# Validation Report

## VALIDATION OF THE CDM-PROJECT: HUANGHE TONGLI WHR PROJECT

REPORT NO. 1017076

2008, June 090

#### Specific Investment of Waste Heat Recovery Projects in China (Source: UNFCCC/TÜV SÜD)

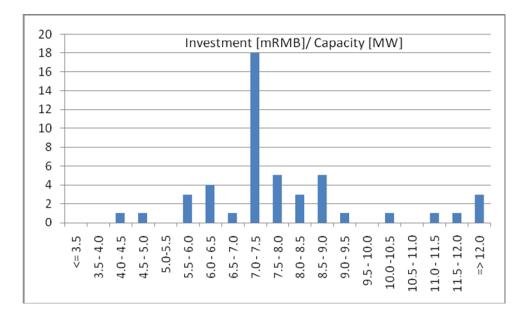
The DOE shall confirm how it has validated that the input values of the IRR meet the requirements of EB 38 paragraph 54 (c).

The input values have been carefully checked and are all based on a third party assessment (The Feasibility Study Report issued by Luoyang heavy industry mine machinery engineering design institute).

To provide additional certainty that the figures used for the IRR calculation are applicable we are comparing the main parameters with other CDM projects of the same type, in the same industry. For the Tongli Huanghe WHR project the specific investment per MW is 6.69 Mio. RMB / MW and the specific operational costs per year are 1.08 Mio. RMB / MW. The average specific investment per MW in China (based on the evaluation of 56 waste recovery projects in the Cement Sector in China that applied or are applying for CDM) is 7.93 Mio. RMB / MW (see figure below); the average specific operational costs are 0,99 Mio. RMB / MW. For the operational hours the average is 6451 h whereas Huanghe is calculated with 6216 h, the tariff for purchase power from grid is 0.326 RMB / kWh compared to 0.354RMB / kWh as the Chinese average. Hence, it can be confirmed that the Huanghe project does not apply unreasonable assumptions.

The DOE has checked and verified the price for purchase of electricity from grid through invoices. The actual price is actually slightly lower, than the price assumed in the IRR calculation. Hence the calculation can be considered as appropriate and conservative.
